## Comment on os-2022-16

Referee comment on "The role of oceanic heat flux in reducing thermodynamic ice growth in Nares Strait and promoting earlier collapse of the ice bridge" by Sergei Kirillov et al., Ocean Sci. Discuss., https://doi.org/10.5194/os-2022-16-RC1, 2022

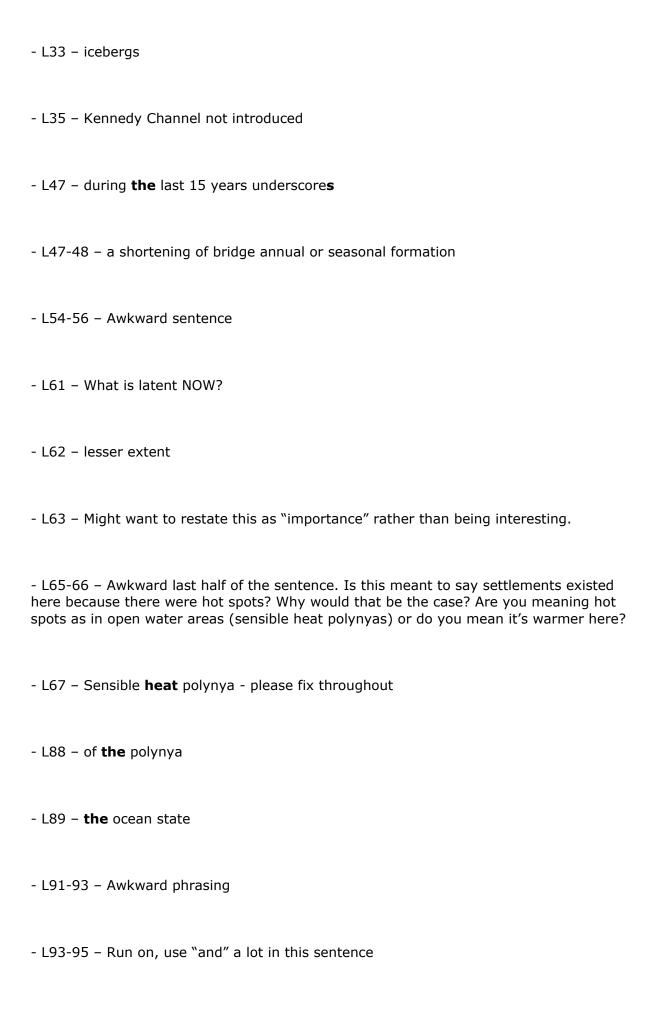
- L105-119 It is unclear what specific products/levels of data were used for this work. Also, please clarify how MODIS "sea surface" brightness temperature (Tb) provides temperatures of sea ice.
- L122-123 Segments are calculated using 150 signal (surface) photons. Photon density varies by surface type and can extend to as much as 150 m so the segment lengths listed here are not accurate as described. The ATL07 description should be adjusted to include this.

- L124-131 - Authors mention they can use one method for determining freeboard heights in some instances and use relative heights to produce maps. It isn't clear what analyses in the results use the first method versus the second. - L135 - Why the uncertainties are small is unclear. References would help. - L132-141 - The methods here are unclear. It is unclear what (if) the authors are doing about the uncertainties mentioned, implications for the study, and if these uncertainties are problematic enough to prevent being able to use them. See the subsequent comments. - L137-141 - It isn't clear how this statement is pertinent to your method. Are you mentioning issues with determining snow height depth in general for ICESat-2, adjusting sea ice freeboard for discrepancies in mean snow depth, or stating ICESat-2 data is unusable? This needs more clarification here. - L149 - What is PHC3 climatology and JRA55-do? It hasn't been introduced. Also, need to write out "high resolution." - L160-163 - The phrase "We have to admit" can be cut. Additionally, it isn't clear from how this is worded whether this is a significant problem for the study or not, how it will create issues or not, or how you mitigate the issues. My assumption is that this statement should read more like "Despite..., a dearth of bathymetry data in Kane Basin adds uncertainty to the models by... A large number of floating and grounded icebergs that originate from the Humboldt Glacier may also...." - L178-179 - What are the other parameterizations and why were they ruled out? I see this was mentioned later so it would be good to mention here that this analysis is included in a subsequent section. - L188-189 - Why are sea surface brightness images not shown? It would be helpful to include these temps in a figure. - Figure 3 - Some of these images look like they may not have open ocean along the ICESat-2 tracks. Are all of the offsets being calculated by the same method in this figure?
